Well Name: SUNDANCE FEDERAL	Well Location: T24S / R31E / SEC 4 / NENE /	County or Parish/State: EDDY / NM
Well Number: 26	Type of Well: OIL WELL	Allottee or Tribe Name:
Lease Number: NMNM104730	Unit or CA Name:	Unit or CA Number:
US Well Number: 3001533724	Well Status: Producing Oil Well	Operator: OXY USA INCORPORATED

Notice of Intent

## Approved BLM procedure

### Revised Procedure

Proposed Wellbore  
**Sundance Federal #26**  
30-015-33724

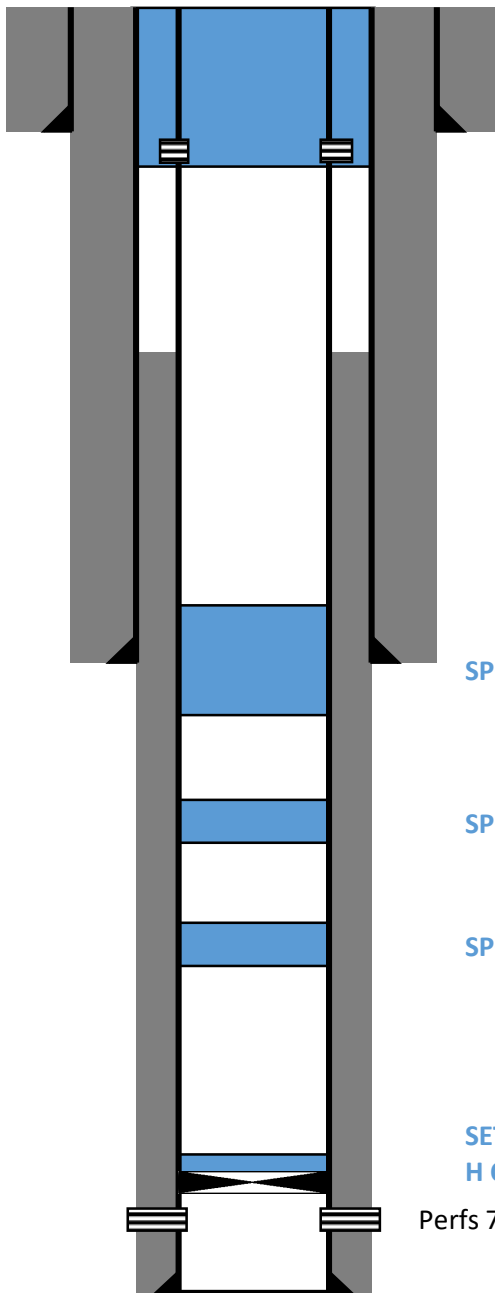
PERF @ 1076'. SQZ AND CIRC  
340 SX C CMT TO SURFACE.

SET CIBP 7804'. DUMP BAIL 5 SX  
H CMT.

1. POOH with production equipment. SET CIBP 7804'. DUMP BAIL 35 ft H CMT.
  2. SPOT 25 SX C CMT 6512'-6225'.
  3. SPOT 25 SX C CMT 5415'-5127'.
  4. SPOT 35 SX C CMT 4363'-4012'.
  5. PERF @ 2000'. SQZ AND CIRC FROM 2000' - SURFACE.
- 10# MLF between plugs. Utilize above ground steel tanks.
